UNITED STATES PATENT AND TRADEMARK OFFICE

APPLICATION NO.	FILING DATE	FIRST NAMED INVENTOR	ATTORNEY DOCKET NO.	CONFIRMATION NO.
10/523,584	02/04/2005	Patrick Dupont	1200.726	1362
7590 12/05/2007				
Liniak Berenato Longacre & White Suite 240 6550 Rock Spring Drive Bethesda, MD 20817				
			EXAMINER	
			LUONG, VINH	
			ART UNIT	PAPER NUMBER
			3682	
			MAIL DATE	DELIVERY MODE
			12/05/2007	PAPER

Office Action Summary

FIG. 4

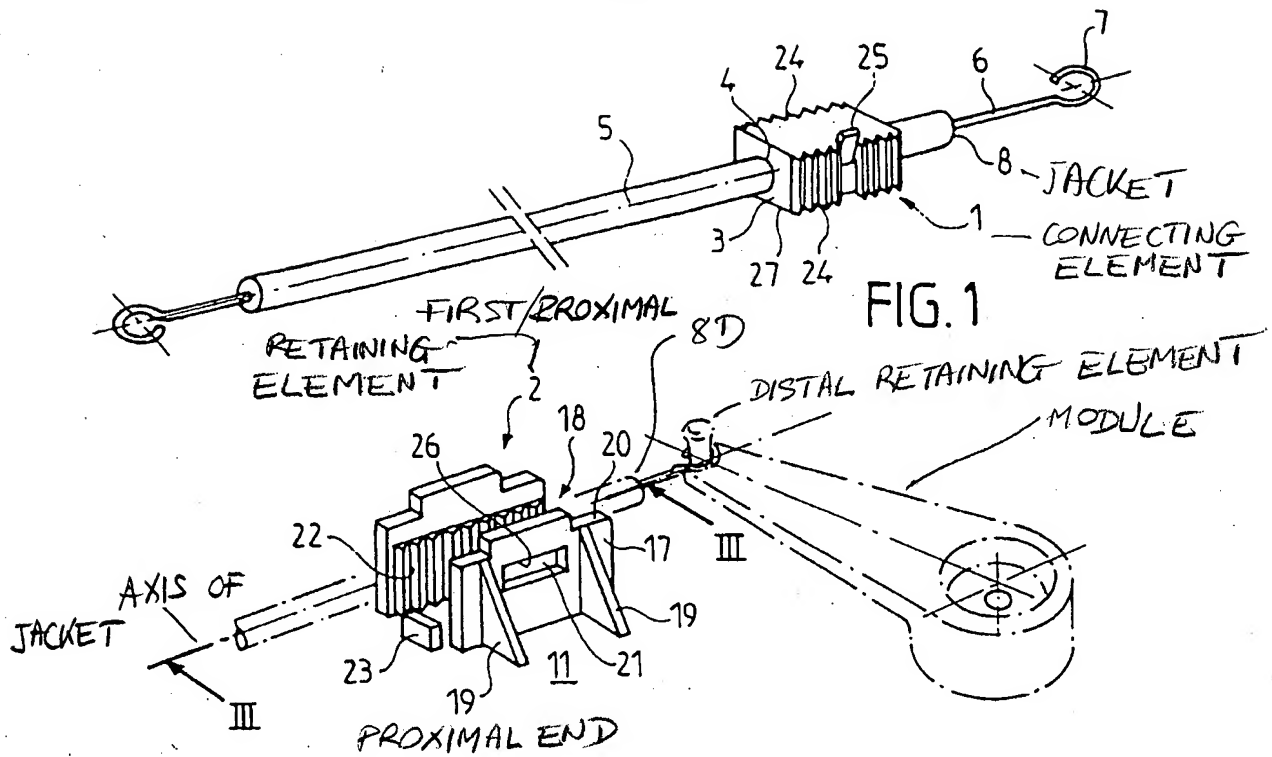
Regarding Claim 14, said weld interface 22 is disposed within an enclosed space defined between the connecting element 1 and the first retaining element 2 as seen in FIGS. 4, 10, and 9.

Regarding Claim 15, said weld interface 22 comprises ribs 22 extending longitudinally on either side of the jacket 8 (FIG. 4) and two welding shoulders 28 and 20 (FIG. 9) extending longitudinally on either side of the jacket 8.

FIG. 5

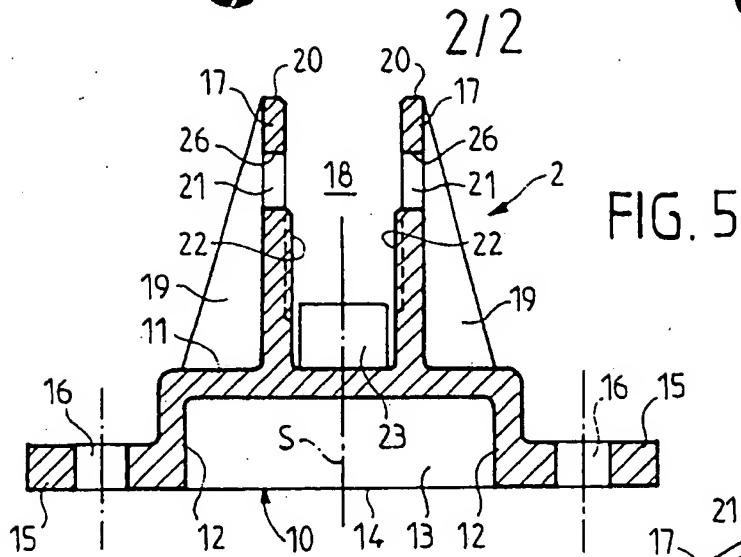
Regarding Claim 6, the interlocking part 24 of the first retaining element 2 forms a longitudinal channel 18 (Fig. 5) for the interlocking of the connecting element 1, the welding face 22 of the first retaining element 2 forming a base of the channel 18, the fusible ribs 22 of the first retaining element 2 extending longitudinally.

FIG. 6

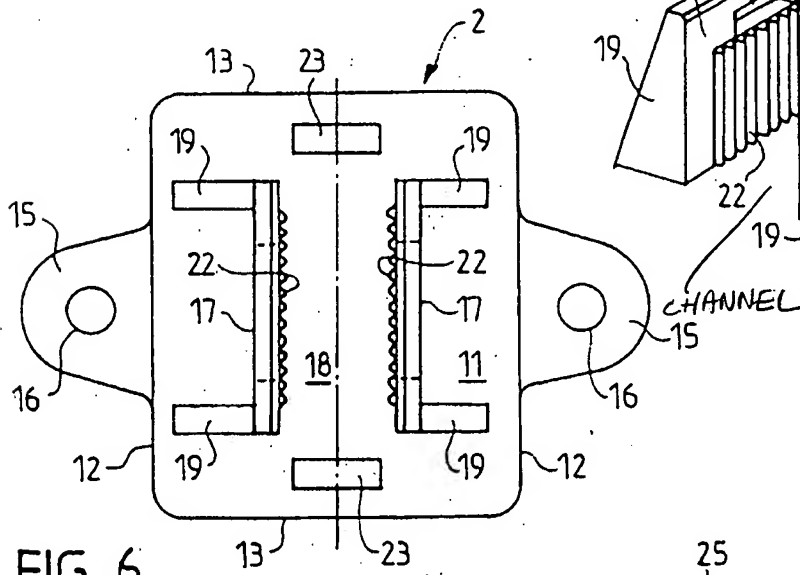
Regarding Claim 8, the first retaining element 2 contains two fusible ribs 22 extending longitudinally on either side of the jacket 8 and two fusible welding shoulders 20 extending longitudinally on either side of the jacket 8, the fusible ribs 22 and the fusible welding shoulders 20 of the first retaining element 2 thus being offset laterally with respect to the axis (III-III in FIG. 2) of the jacket 8 as seen in FIGS. 4, 6, and 10.

FIG. 9

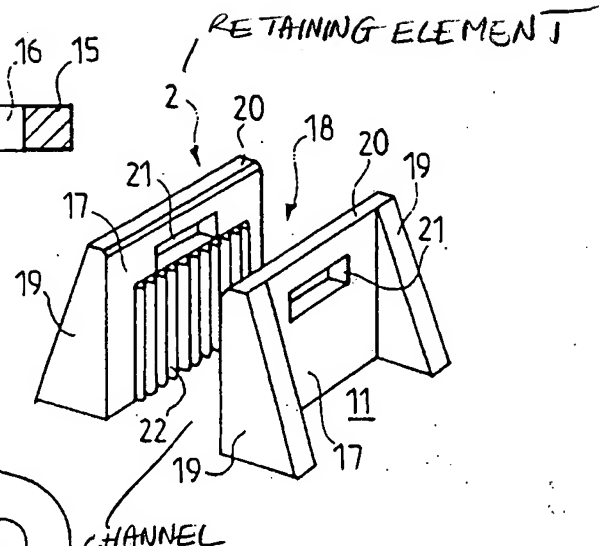
Regarding Claim 7, the complementary interlocking parts 24 and 22 of the connecting element 1 and of the first retaining element 2 comprise fusible complementary welding shoulders 28 and 20 (Fig. 9).

FIG. 8

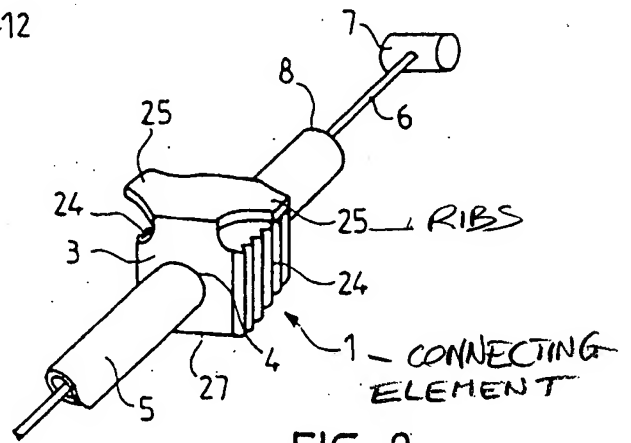
Regarding Claim 11, the proximal end (8P in Att.) of the cable 6 is provided with a block 7 (Fig. 8) for securing this cable 6, the shell 12 forming a housing for the securing block 7.
